Report to Planning and Environment Committee

Subject: 1120-1126 Oxford Street East and 2 & 6 Clemens Street
Public Participation Meeting
City File No: Z-9560 Ward 4

Date: May 23, 2023

Figure 2: Site concept plan (original proposal)

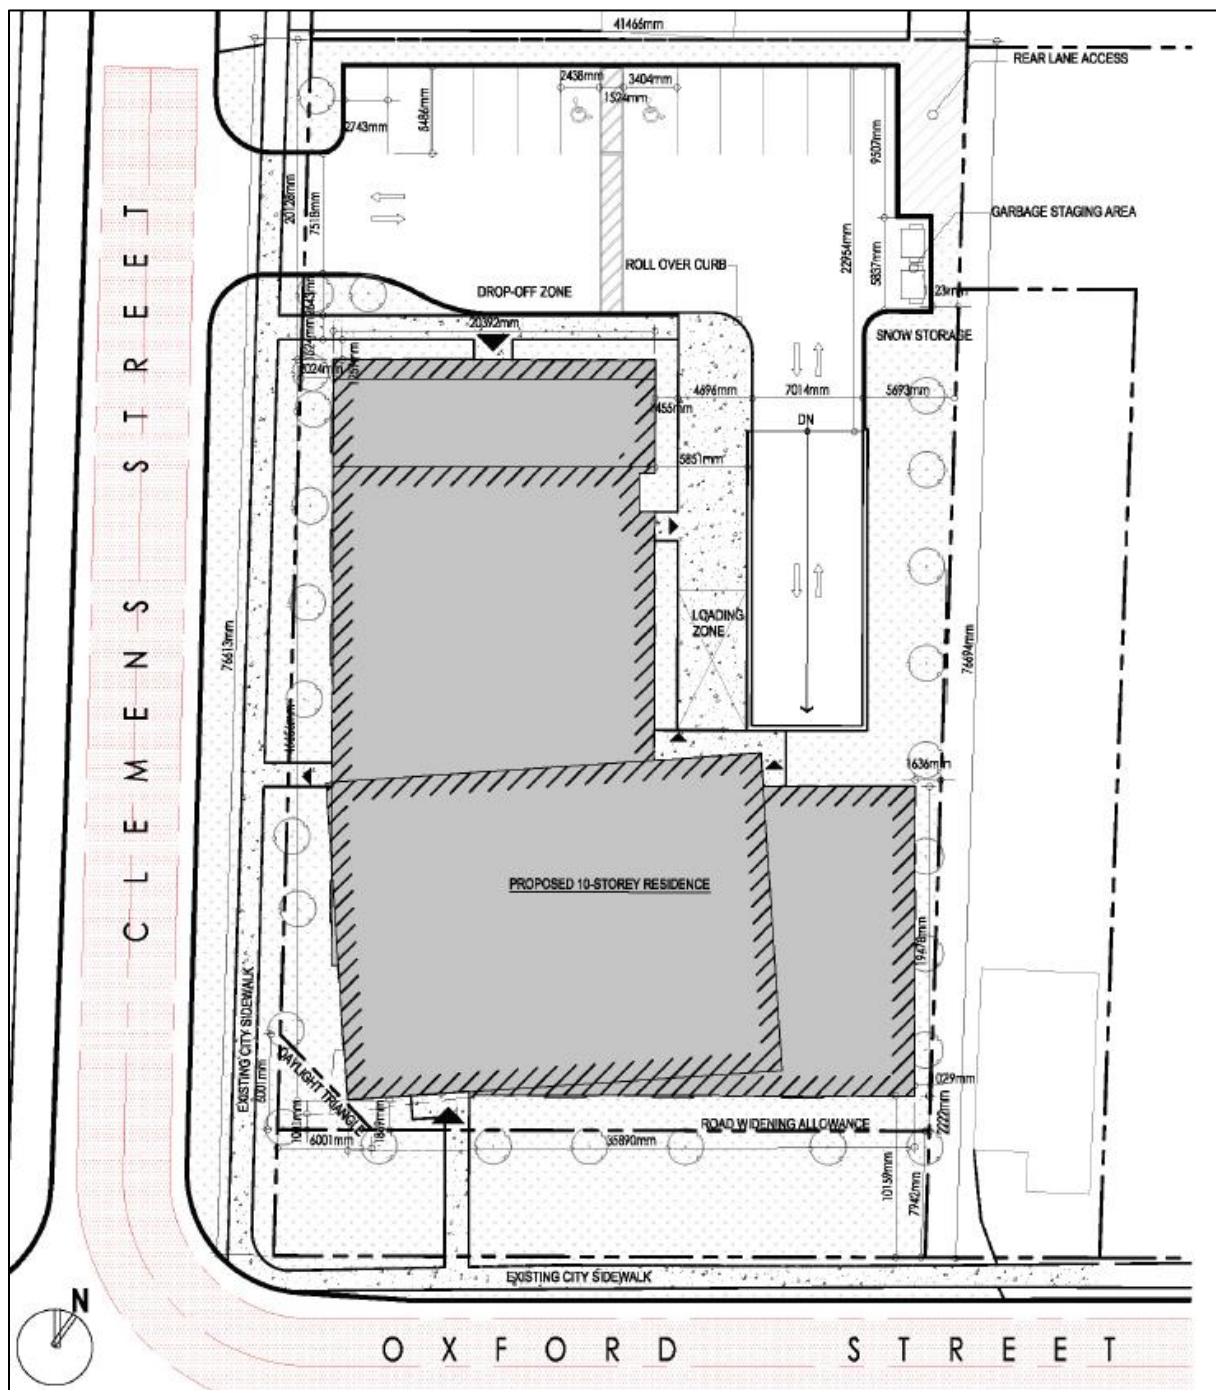
Through the review of the application, staff raised several concerns with the proposed development. The original development concept proposed an easterly interior side yard depth of 1 metre, with residential units and balconies proposed, which staff raised concern with. In addition, staff raised concern that the site lacks an adequately sized and centrally located outdoor amenity area. Staff also requested a larger stepback and greater transition in height be provided at the rear of the building.

Through the review of the application, the applicant amended the proposed development in response to departmental/agency comments. The requested amendment was revised to permit a 10-storey, 131-unit apartment building. The requested amendment was revised to request the following special provisions:
